SUBJECT: Forwards first draft Tech Specs. Justification to support proposed changes provided in separate encl package. *see Tech Specs*

August 2, 1985
(NMP2L 0460)

Re: Nine Mile Point Unit 2
Docket No. 50-410

Enclosed are seven (7) copies of the Nuclear Regulatory Commission's first draft (July 19, 1985) of the Nine Mile Point Unit 2 Technical Specifications. These copies have been pen and ink marked to show our comments and proposed changes. Justification to support our proposed changes has been provided in a separate enclosed package.

FIGURE 3.1.5-1 SODIUM-PENTABORATE TANK VOLUME vs CONCENTRATION REQUIREMENTS

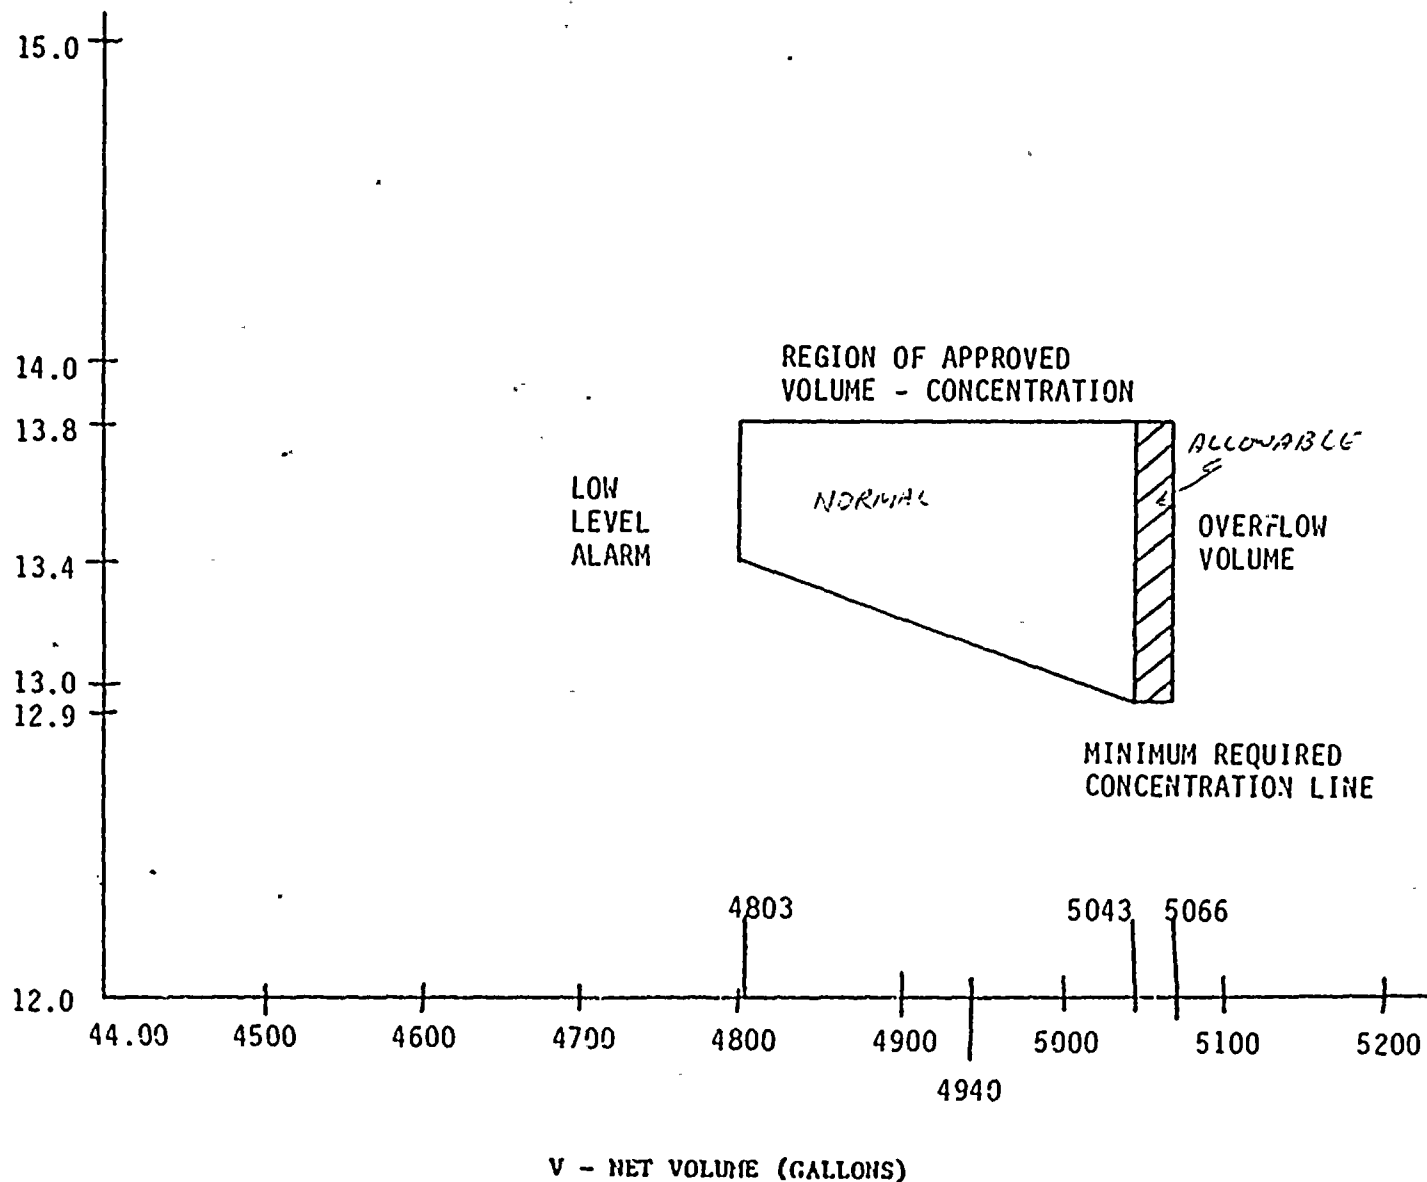
- a. At least once per 24 hours by verifying that;
 1. The temperature of the sodium pentaborate solution ~~is within the limits of Figure 3.1.5-1.~~ ^{in the storage tank} $\geq 70^{\circ}\text{F}$ or Figure 3.1.5-2.
 2. The available volume of sodium pentaborate solution is greater than or equal to () gallons; ^{within the limits of figure 3.1.5-1.}
 3. ~~The heat tracing circuit is OPERABLE by determining the temperature of the (pump suction piping) to be greater than or equal to $(70)^{\circ}\text{F}$. or Figure 3.1.5-2.~~

- b. At least once per 31 days by:
1. Verifying the continuity of the explosive charge.
 2. Determining that the available ^{net} weight of sodium pentaborate is greater than or equal to ~~(5680)~~ lbs and the concentration of boron in solution is within the limits of Figure 3.1.5-1 by chemical analysis.*

*This test shall also be performed anytime water or boron is added to the 70°F solution or when the solution temperature drops below ~~the limit of Figure 3.1.5-1~~

Figure 3.2.1-1

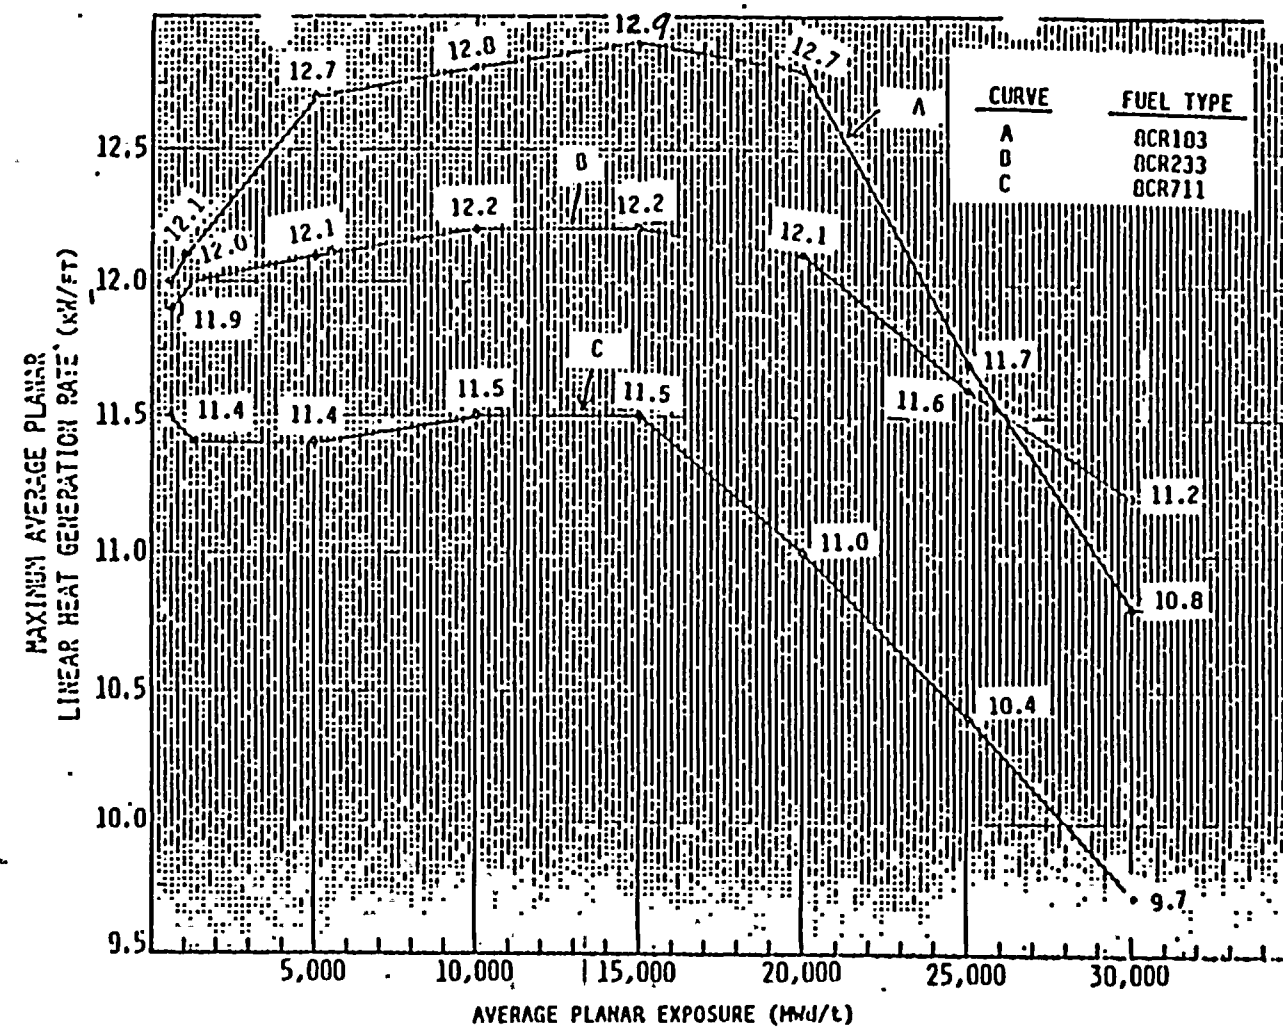
3.2.1 All AVERAGE PLANAR LINEAR HEAT GENERATION RATES (APLHGRs) for each type of fuel as a function of AVERAGE PLANAR EXPOSURE shall not exceed the limits shown in Figure 3.2.1-1, ~~3.2.1-2, and 3.2.1-3.~~

With an APLHGR exceeding the limits of Figure 3.2.1-1, ~~3.2.1-2, or 3.2.1-3,~~ initiate corrective action within 15 minutes and restore APLHGR to within the required limits within 2 hours or reduce THERMAL POWER to less than ~~25%~~ of RATED THERMAL POWER within the next 4 hours.

4.2.1 All APLHGRs shall be verified to be equal to or less than the limits determined from Figures 3.2.1-1, ~~3.2.1-2, and 3.2.1-3:~~

FIGURE 3.4.6.1-1a MINIMUM REACTOR VESSEL TEMPERATURE FOR
PRESSURIZATION DURING HYDROSTATIC TESTING
(REACTOR CORE NOT CRITICAL)

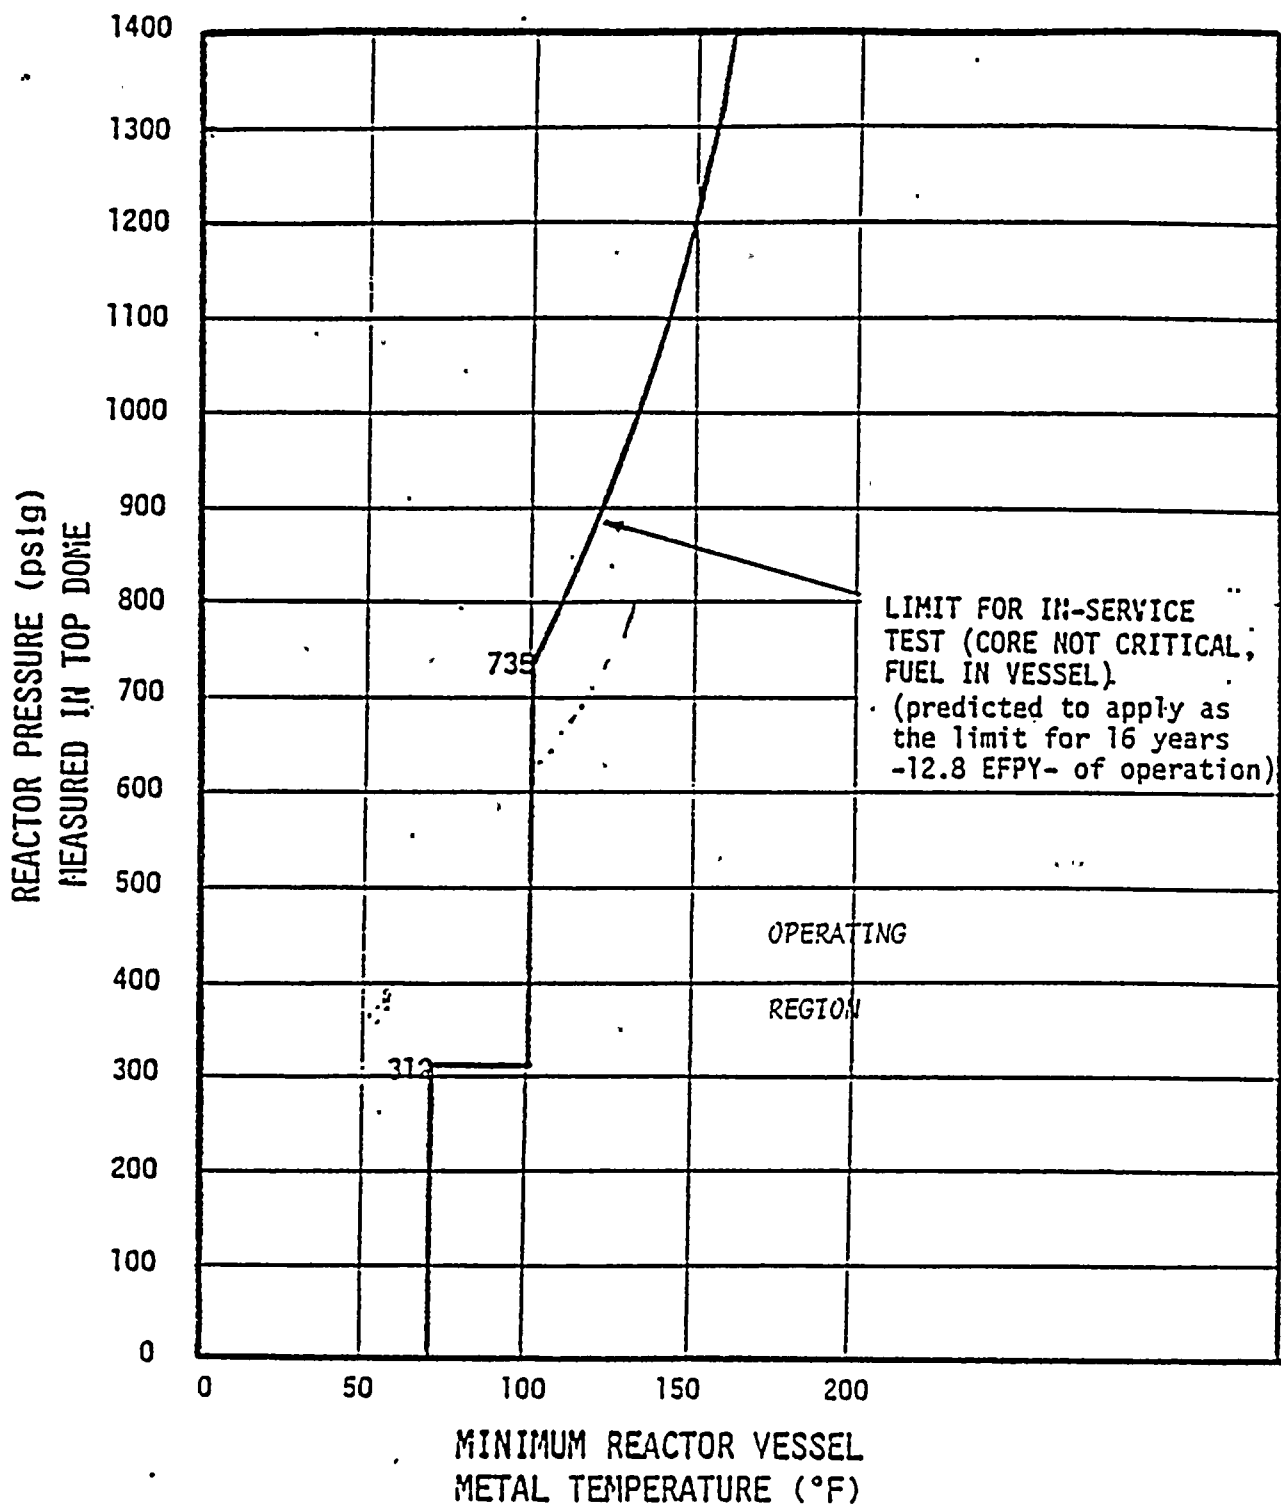
3.4.6.1 The reactor ~~coolant system temperature and pressure~~ shall be limited in accordance with the limit lines shown on Figures 3.4.6.1-1 (1) ~~curves A and A'~~ for hydrostatic or leak testing; (2) ~~curves B and B'~~ for heatup by non-nuclear means, cooldown following a nuclear shutdown and low power PHYSICS TESTS; and (3) ~~curves C and C'~~ for operations with a critical core other than low power PHYSICS TESTS, with: figure c figure b

4.4.6.1.1 During system heatup, cooldown and inservice leak and hydrostatic testing operations, the reactor ~~coolant system temperature and pressure~~ shall be determined to be within the above required heatup and cooldown limits and to the right of the limit lines of Figure 3.4.6.1-1 curves A and A' or B and B' as applicable, at least once per 20 minutes. vessel pressure and metal temperature of the reactor vessel flange surfaces, bottom outside surface and bottom head inside surface, as measured by the bottom head drain temperature shall be determined to be to the right of the region defined by Figures 3.4.6.1-1a, b, c at least once per 30 minutes. steam space

FIGURE 5.1-1

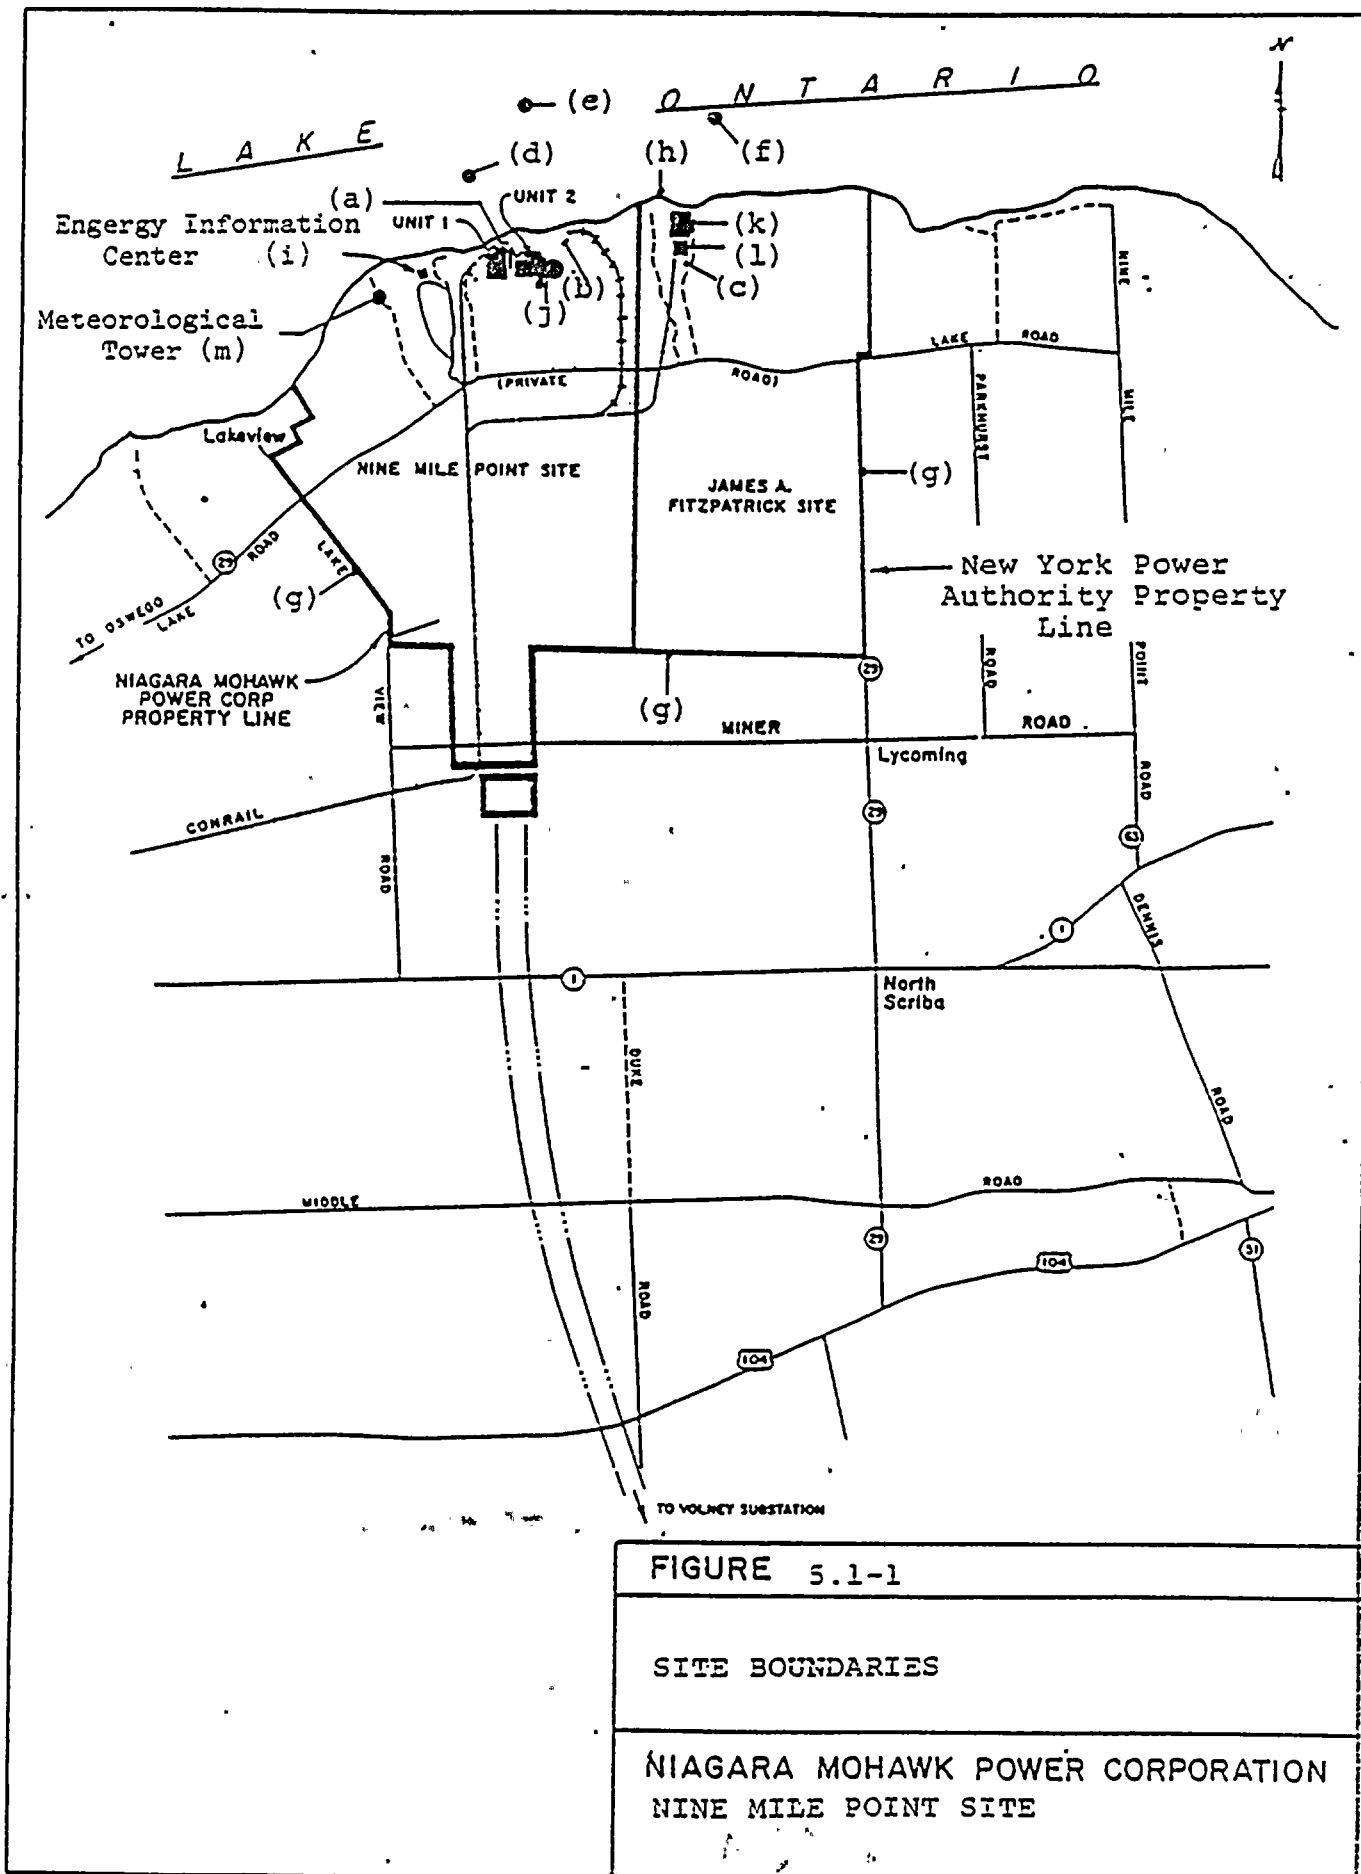
Notes to Figure 5.1-1 were provided. LPZ information is contained in the Safety Evaluation Report, and is not useful for the Tech. Spec.
